Subject: MULTIPLE ELECTRICAL MALFUNCTIONS AFTER BODY REPAIR	Bulletin No: 09-022/14
	Last Issued: 05/30/2014

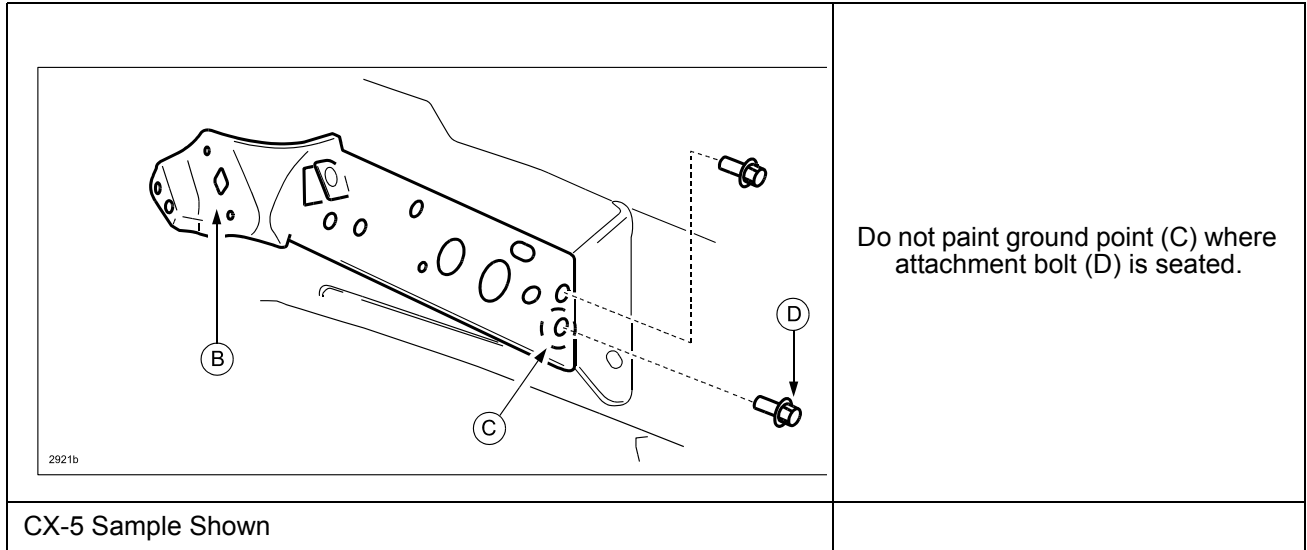
The front fender stay (B) newly painted surface at ground point (C), where attachment bolt (D) is seated, may create a poor front harness ground connection.

Customers concern can be resolved by sanding off paint at ground point (C) where attachment bolt (D) is seated. After installing the bolt (D), apply touch-up paint to the exposed base material area of the front fender stay.

NEWLY INSTALLED FRONT FENDER STAY NOTE

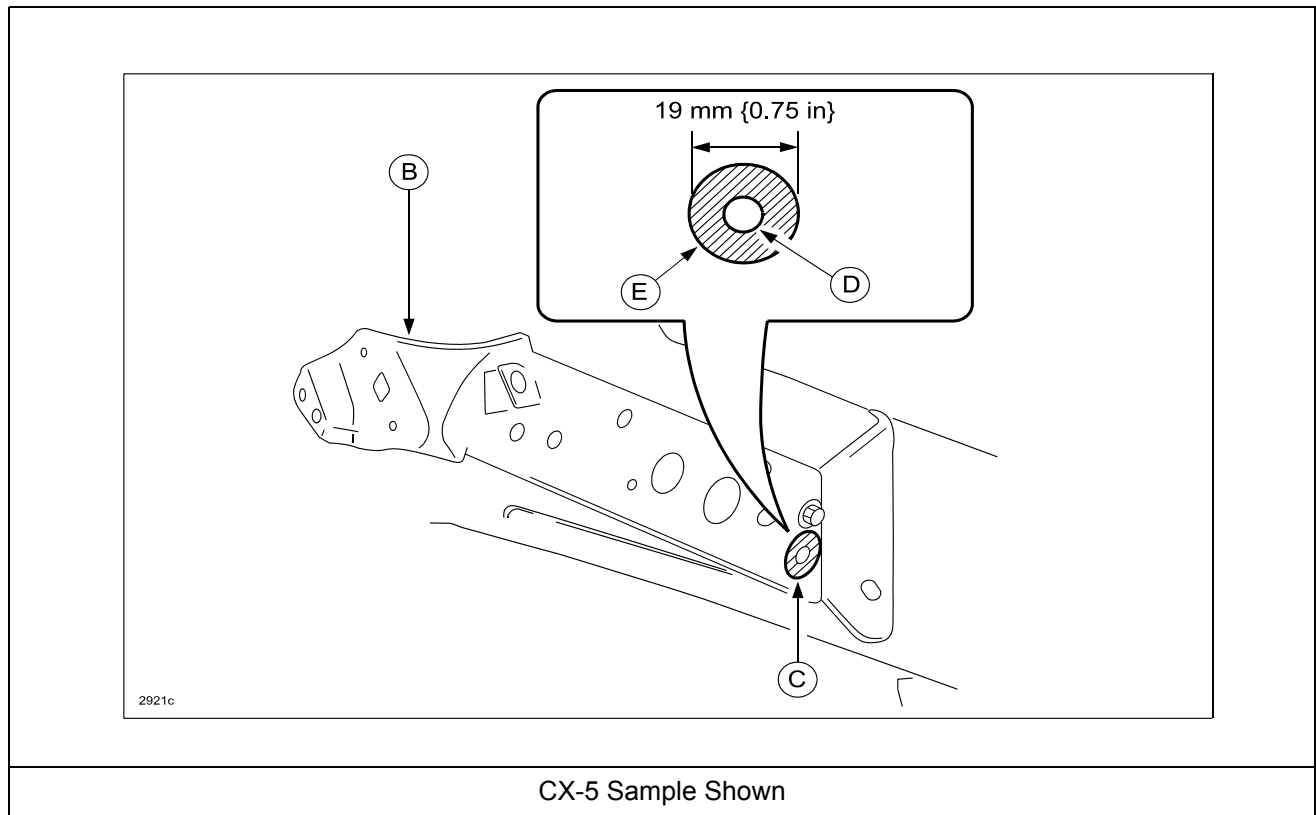
CAUTION: If the bolt (D) contact area (C) is painted when the front fender stay (B) is newly replaced, it could cause a malfunction in the PCM. Before painting a newly replaced part, protect the bolt (D) contact area (C) with masking tape (E) as shown in the figure.

NOTE: After installing the bolt (D), apply touch-up paint to the exposed base material area of the front fender stay.
